FORM EQP 5111 ATTACHMENT TEMPLATE B3 HYDROGEOLOGIC REPORT

This license application template addresses requirements for a hydrogeologic report for the hazardous waste management units and the hazardous waste management facility for the Wayne Disposal, Inc. facility in Belleville, Michigan. This template includes hydrogeologic report requirements, waiver demonstrations, and alternative information requests for operating license applications. This hydrogeologic report supplies information to support the groundwater monitoring program, or groundwater monitoring waiver request, proposed and included in Template B5, Environmental Monitoring Programs.

Supplemental Hydrogeologic Information

The following report contains updated information regarding the hydrogeologic conditions at and around the WDI landfill (the Site). The last comprehensive update to the hydrogeologic conditions at and around the Site was done in 2011 as part of a hazardous waste license application. The 2011 Hydrogeologic Report (HR) was prepared by NTH Consultants, Ltd. was also submitted with WDI's license application in 2021. WDI received a technical notice of deficiency (TNOD) regarding this 2021 license applicat

APPENDIX B. GROUNDWATER CONTOUR MAPS - 2024

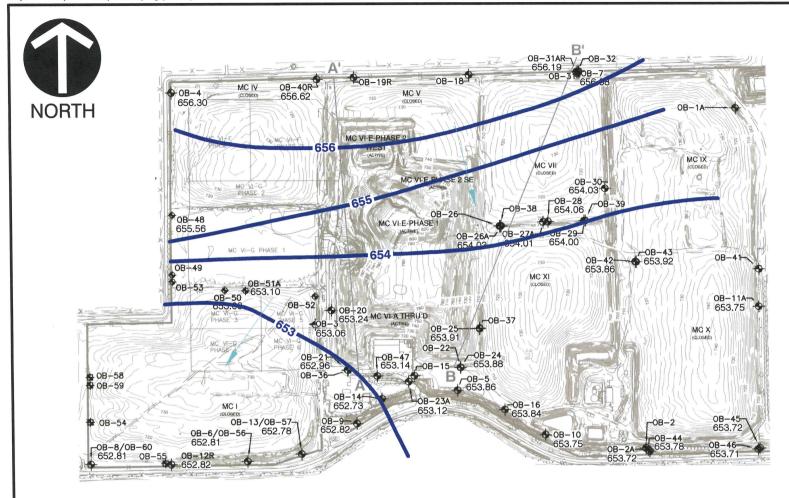
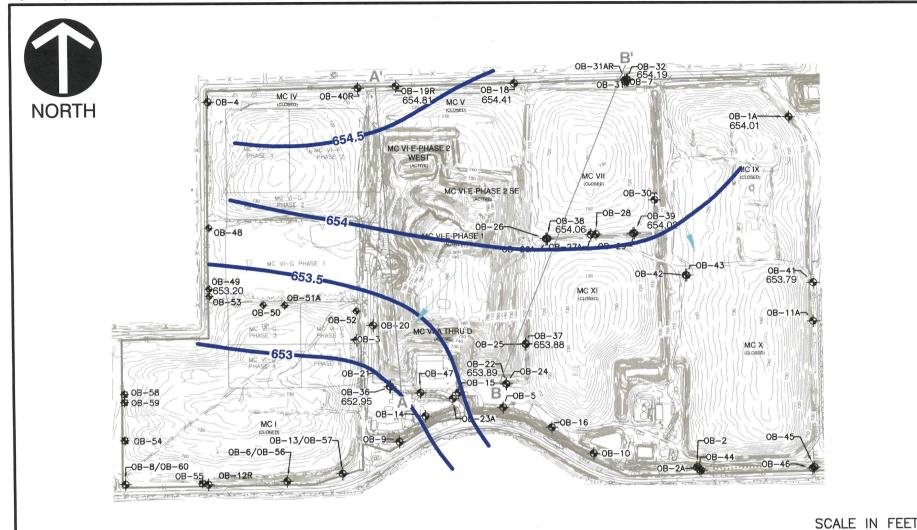
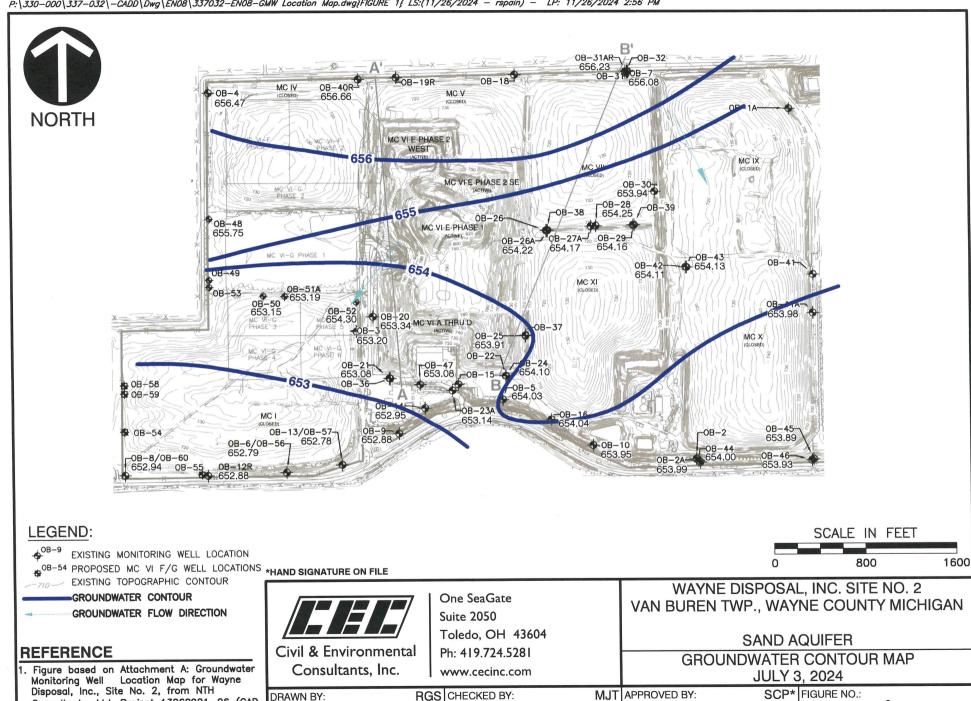
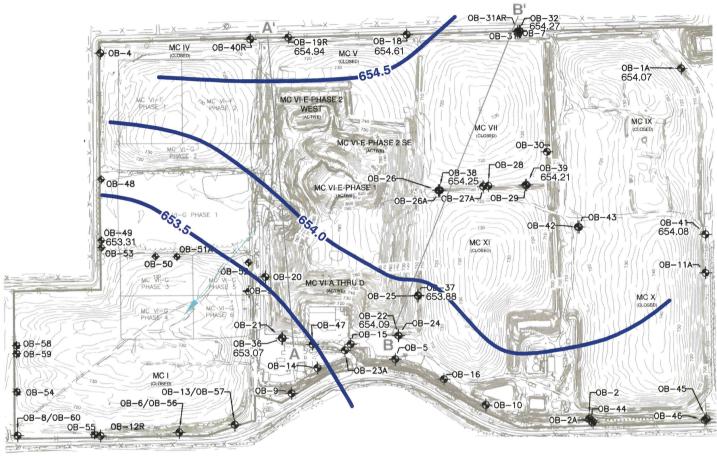
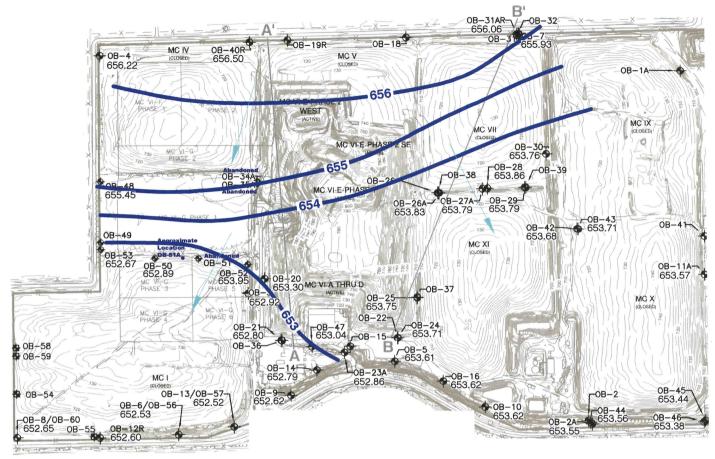
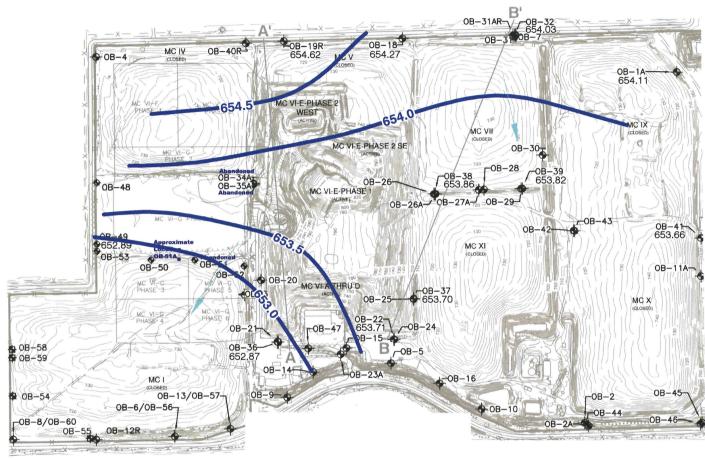
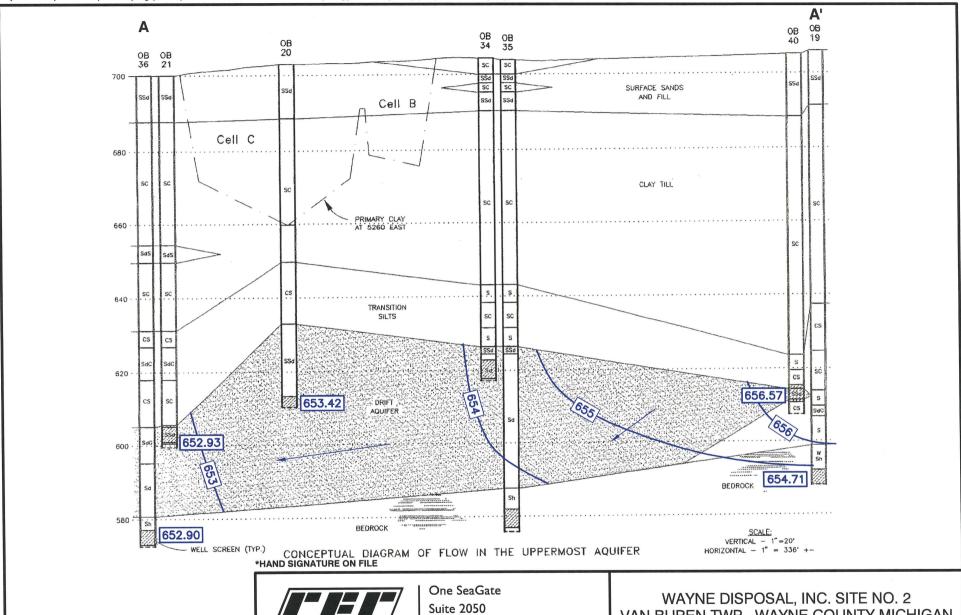
71. Provide current groundwater flow contour maps.

The four quarterly ground water flow maps for the 2024 calendar year are included in Appendix B. Groundwater flow is generally to the south toward Belleville Lake, which is the discharge area for the glacial sand aquifer. Flow toward the southwest in the southwest portion of the Site is present in current and historic measurements and may reflect a change in the hydraulic conductivity in the glacial sand unit in this portion of the site.

APPENDIX C. GROUNDWATER FLOW CROSS-SECTIONS – 2024

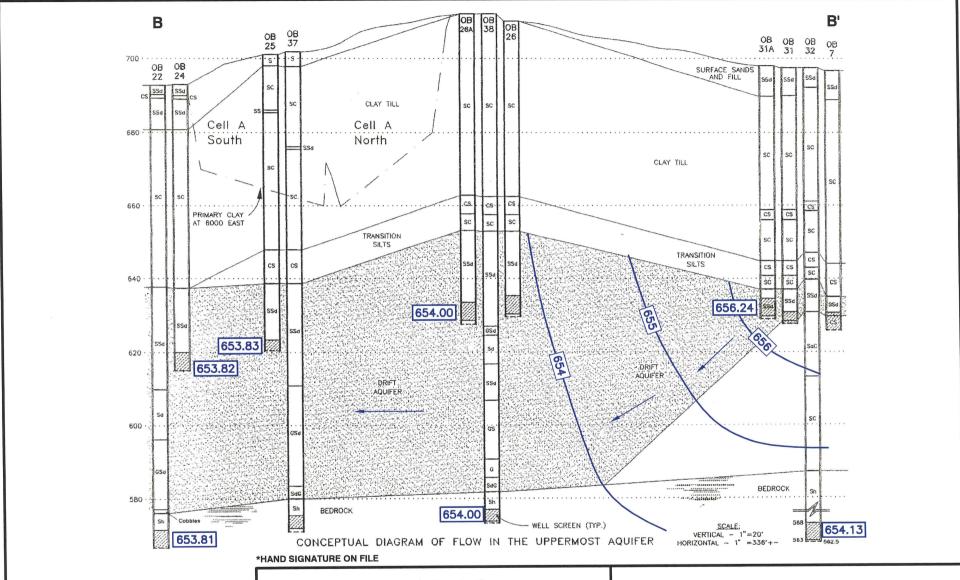
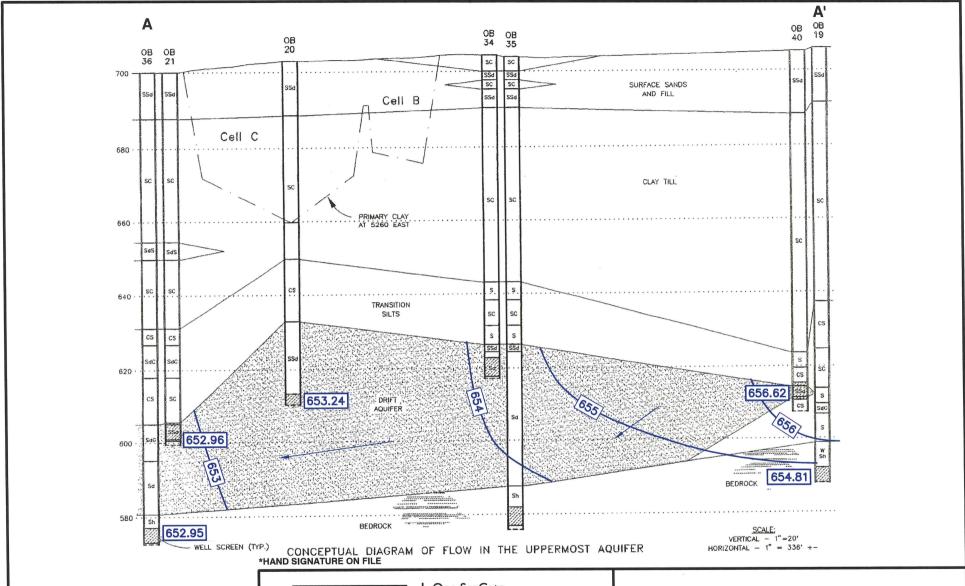
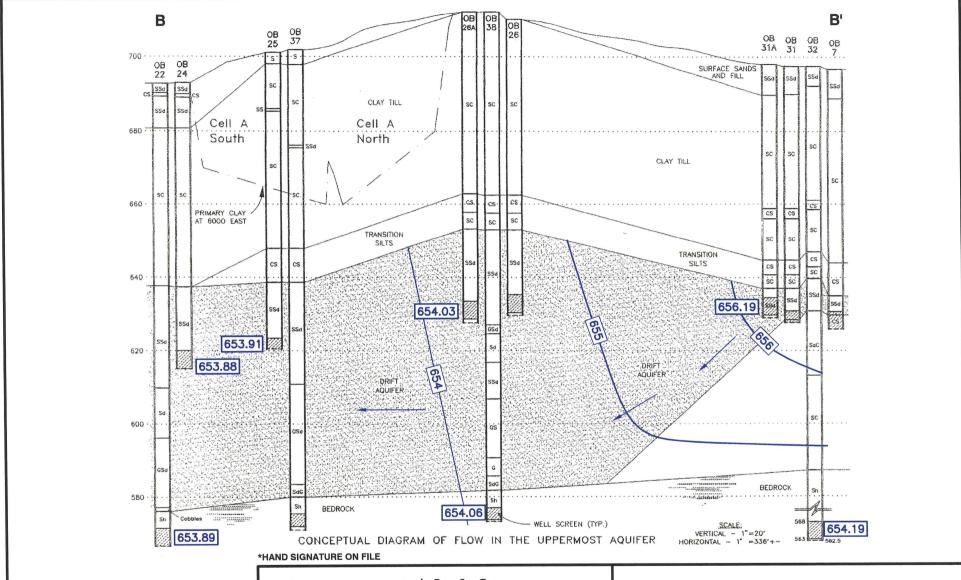
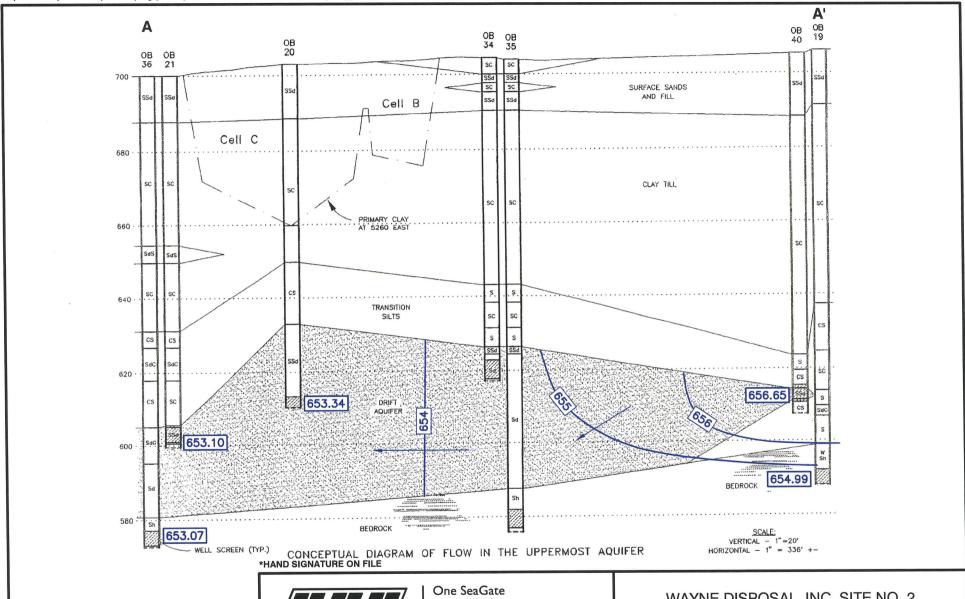
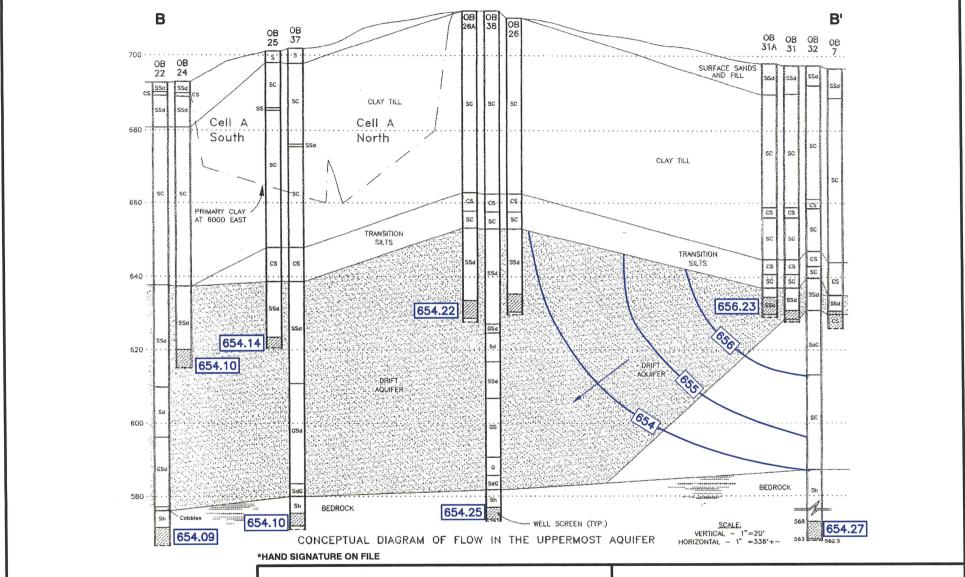
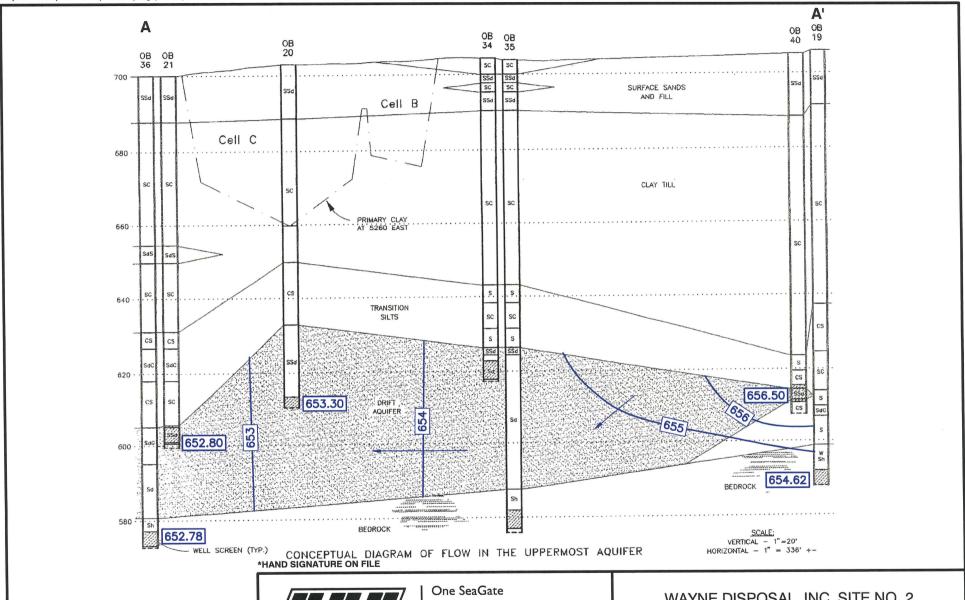
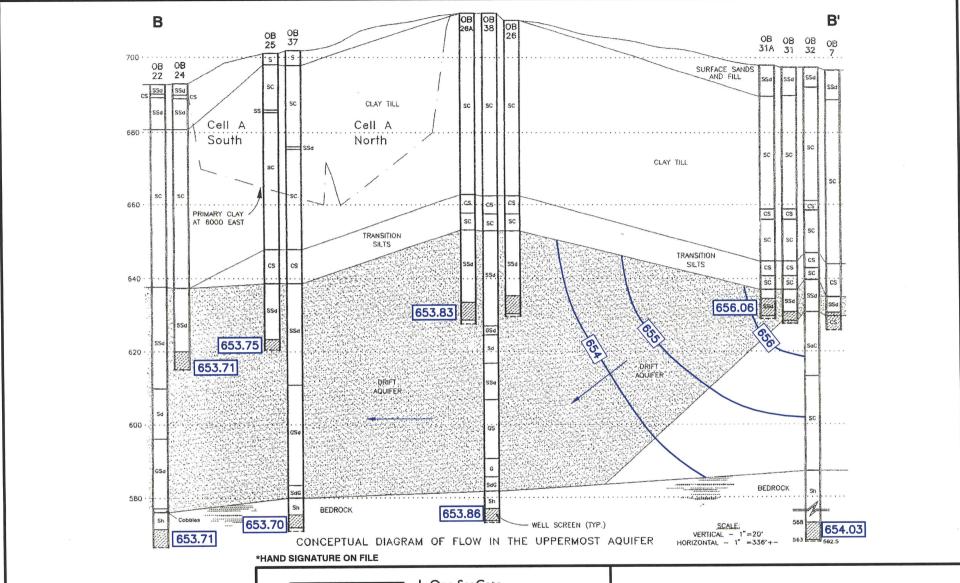
72. Provide revised groundwater flow diagrams for current conditions and include groundwater flow net diagrams.

Quarterly groundwater flow cross-sections for two north-south transects are included in Attachment C. The flow cross-sections represent each of the four quarterly monitoring periods during the 2024 calendar year. The transect locations are shown on the plan view contour maps in Appendix B, labelled A – A' and B - B'. The cross-sections confirm the north to south flow direction displayed in the plan view contour maps, but also show the downward vertical flow component in the upgradient (north) area of the Site as well as the primarily horizontal flow as groundwater flow continues beneath the central and southern portions of the Site.

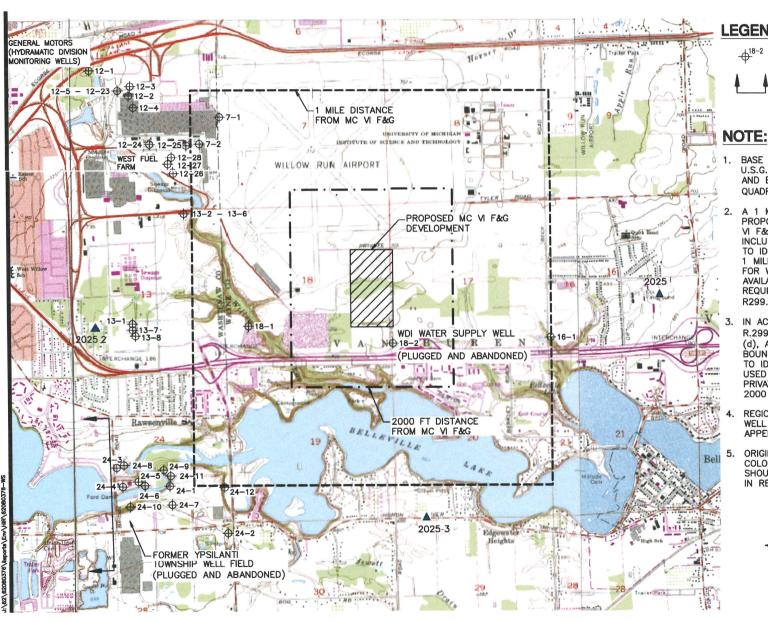
73. Provide the following items on the topographic map:

- a. Waste management areas {R 299.9506(1)(e)(i)}.
- b. Point(s) of compliance {R 299.9506(1)(e)(iii)}.
- c. Locations of groundwater monitoring wells {R 299.9506(1)(e)(iv)}.
- d. All domestic, municipal, industrial, oil, and gas wells and soil boring locations within 1 mile of the site. This should include the extraction wells around the lined pond and West and East Treatment Buildings. {R 299.9506(1)(f)}.

The hazardous waste management area, points of compliance, and location of groundwater wells are shown on the attached Figure 1. The locations of domestic, municipal, industrial and oil/gas wells are shown on an updated copy of Figure 6 from the 2011 Hydrogeological Report, which is included in Appendix D. A search for any new wells or wells that were not included on the original version of Figure 6 yielded three such wells. Each of these three wells are plotted as a triangular symbol on updated Figure 6. The well logs also are included in Appendix D. The three new wells are designated as 2025-1 through 2025-3 on updated Figure 6. Two of the three new wells were installed after the 2011 Hydrogeological Report (2025-1 and 2025-3), and, as shown on updated Figure 6, none are located within a mile of the facility.
